Comment Letter 5

**Re: Comments on the Draft Environmental Impact Report for the
14800 W. Schulte Road Logistics Center Project, PA-1900208
(SA) & PA-2000162 (ER) SCH: 2020110406**

Figure 3: Modeled DPM Concentrations from Unmitigated Project

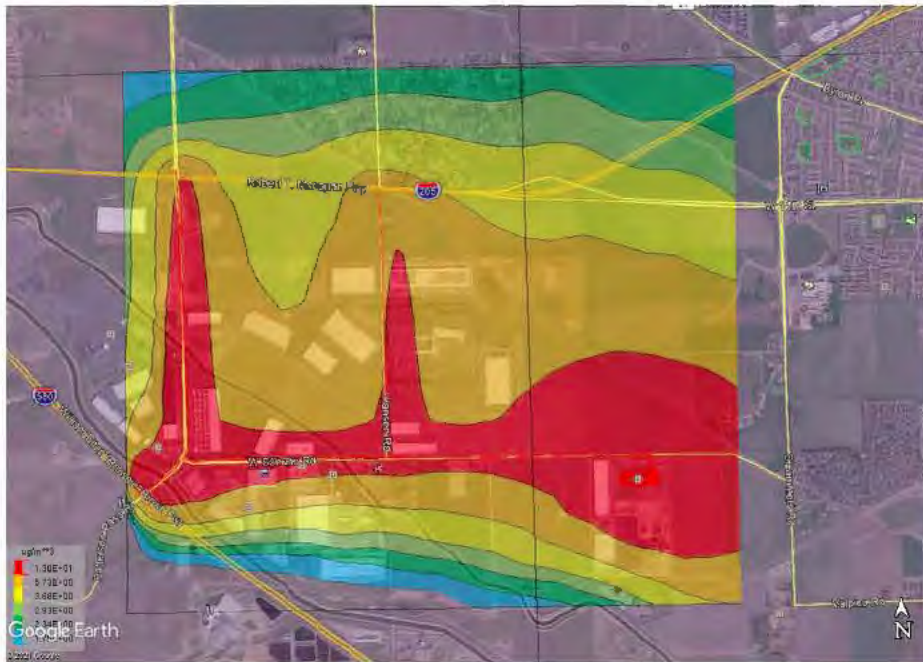
Dr. Clark's modeling of the unmitigated Project is demonstrated in Figure 3 below. The concentrations of DPM in the red band exceed $13 \mu\text{g}/\text{m}^3$, a risk to workers at other locations in excess of 800 in 1,000,000. For any resident in the red band the cancer risk in excess of 1,000 in 1,000,000.⁷⁹

Figure 4: Health Risk From 15-Minute Maximum Idling

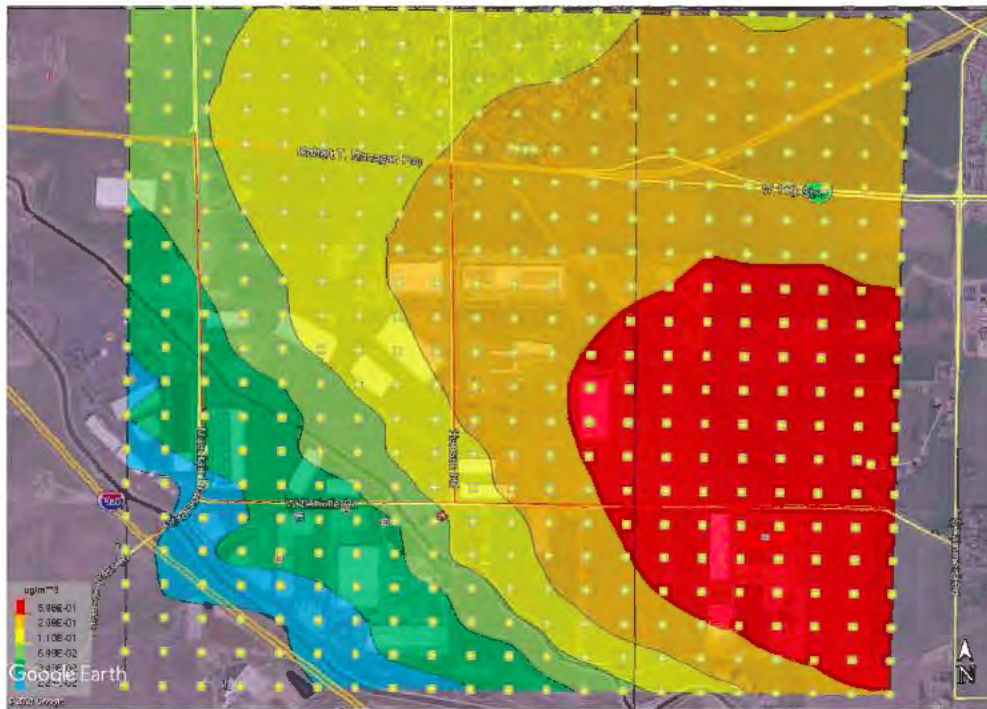
Using the same inputs utilized by the County, Dr. Clark recreated the air model and found that the unmitigated emissions from onsite emissions would pose a risk to not only the nearest residence to the west but to the residences located approximately 0.3 miles to the east northeast of the site on South Lammers Road as well as the workers onsite.⁸⁰ The concentration of DPM from idling vehicles at the closest residence on South Lammers Road was $2.58 \mu\text{g}/\text{m}^3$, equal to a cancer risk of 2,000 in 1,000,000.⁸¹

Figure 5: DPM Concentration Based on Maximum Total Idling Time of 5 Minutes

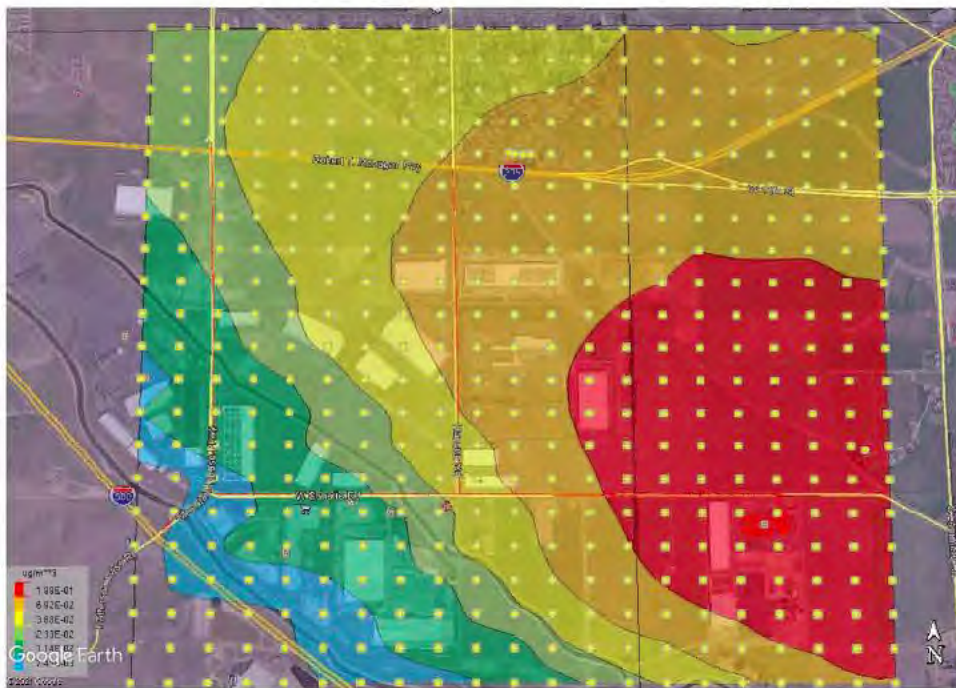
Furthermore, Dr. Clark found that, even when the idling time on site is reduced to the 5-minute maximum per CARB guidance, the emissions still present a risk to the community.⁸² The concentration of DPM from idling vehicles at the closest residence on South Lammers Road was $0.861 \mu\text{g}/\text{m}^3$, equal to a cancer risk of 744 in 1,000,000.⁸³ Based on Dr. Clark's findings, the DEIR fails to adequately analyze the impacts of the Project and it is evident that the 5-minute maximum idling period will be insufficient to mitigate the impacts of the Project.

Figure 6: Concentration of DPM from Roadway Emissions Associated with Project

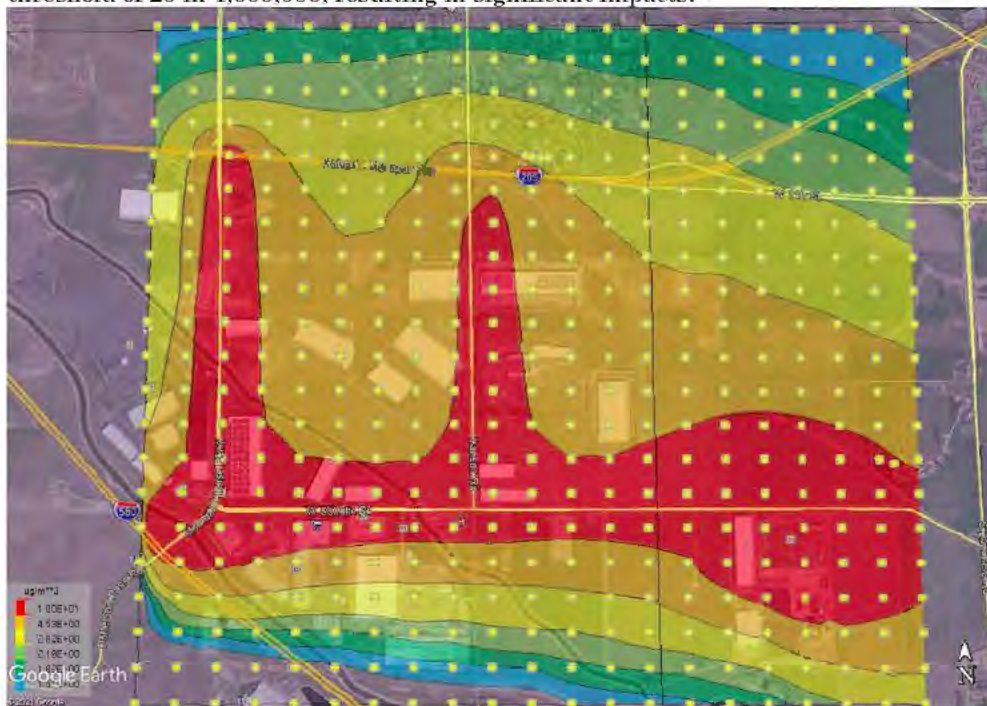
Finally, Dr. Clark explains that there is a substantial risk posed by diesel emissions from trucks moving through the community which the DEIR fails to address.⁸⁴ Using the same model outputs as described above Dr. Clark identified that, as seen in Figure 6, the businesses along West Schulte Road, Hanson Road, and Mountain House Parkway are in excess of 10 µg/m³, equal to a cancer risk of 618 in 1,000,000. These concentrations are well in excess of SJVAPCD's significance threshold of 20 in 1,000,000, resulting in significant impacts.⁸⁵

Additional mitigation measures are required to address the significant health impact that will result from the Project. Dr. Clark proposes that the County must reduce the number of vehicles that access the site and travel along the roadways, reduce the idling time even more than the proposed 5 minutes, and find alternative fuel sources for vehicles accessing the site.⁸⁶ The results of Dr. Clark’s research must be evaluated and addressed by the County in a revised EIR.
